**AMENDMENT NO. 1 JUNE 2005
TO
IS 6523 : 1983 SPECIFICATION FOR
PRECAST REINFORCED CONCRETE DOOR AND
WINDOW FRAMES**

(First Revision)

1A Typical Cross Section of Precast Reinforced Concrete Door and Window Frame
Showing Reinforcement

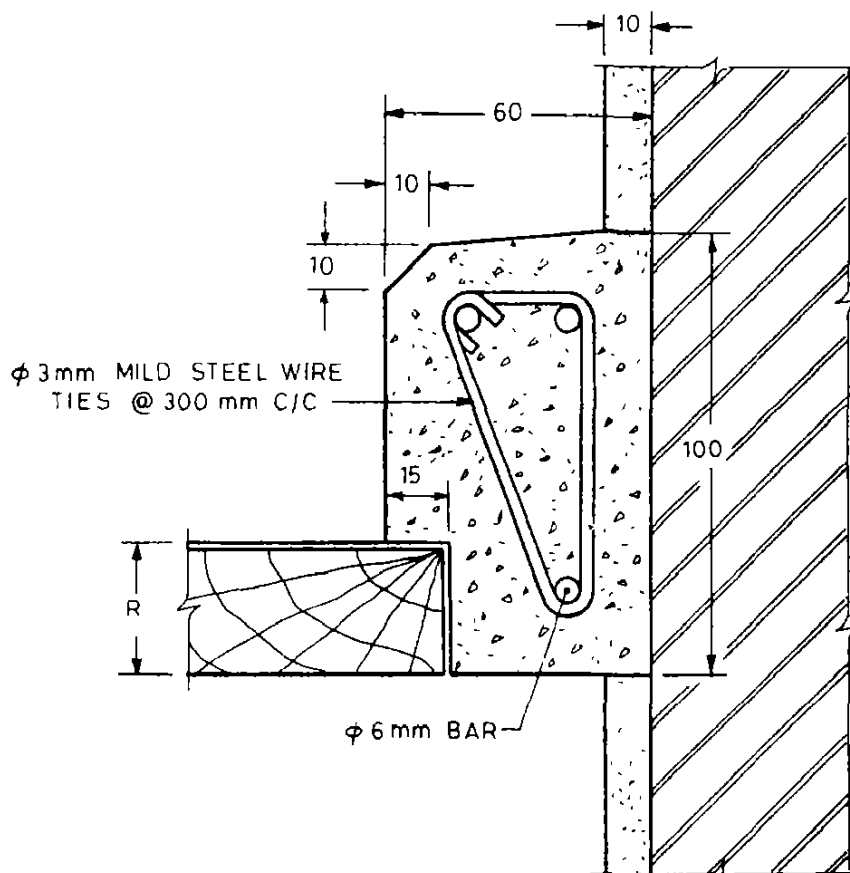
NOTE 3 — A slight slope for ease in demoulding may be provided in frame cross section as shown in Fig. 1A and 1B.'

(Pages 6 and 7, Fig 1A and 1B) — Substitute the following Fig. 1A and 1B for the existing

$R = 30, 35$ or 40 mm depending upon the thickness of shutter
